Subject: Sterling Bullet Left Tie Rod Ends

REVISION: A missing decimal point has been added to the "Important" note above step 25. It now reads, "IMPORTANT: Toe should be set to +0.20 degrees total."

April 2011
FL588A
NHTSA #11V-193
Transport Canada #11-011
REVISED NOTICE

Fig. 3, Measuring Tie-Rod End Angle

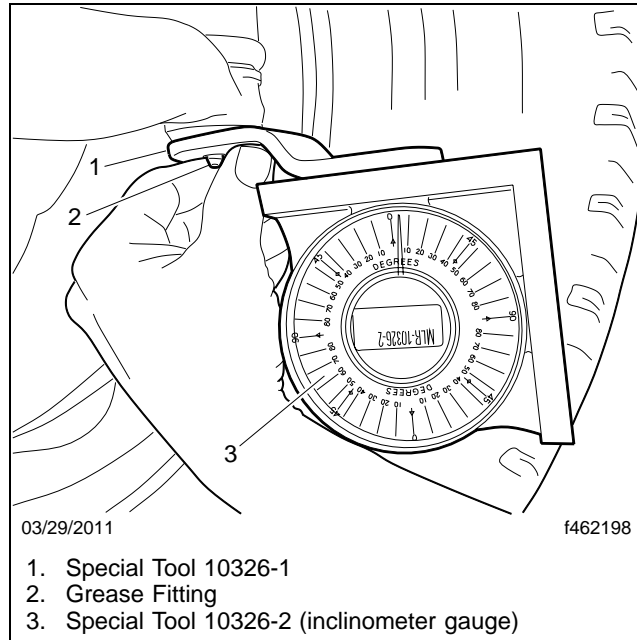
REVISION: A missing decimal point has been added to the "Important" note above step 25. It now reads, "IMPORTANT: Toe should be set to +0.20 degrees total."

IMPORTANT: Toe should be set to +0.20 degrees total.

21. Set the toe and center the steering wheel following the alignment rack manufacturer's instructions.
22. Install special tools 10326-1 and 10326-2 (inclinometer gauge) on the bottom surface of the right tie-rod end. The grease fitting should be centered in the hole on special tool 10326-1. See **Fig. 3**.
23. Measure the angle of the right tie-rod end. Record the number displayed on the inclinometer gauge.
24. Install special tools 10326-1 and 10326-2 onto the bottom surface of the left tie-rod end.

25. Adjust the left tie-rod end so that the same angle appears on the inclinometer gauge as was measured on the right tie-rod end.
26. Tighten the tie rod adjuster clamp 40 lbf·ft (54 N·m).
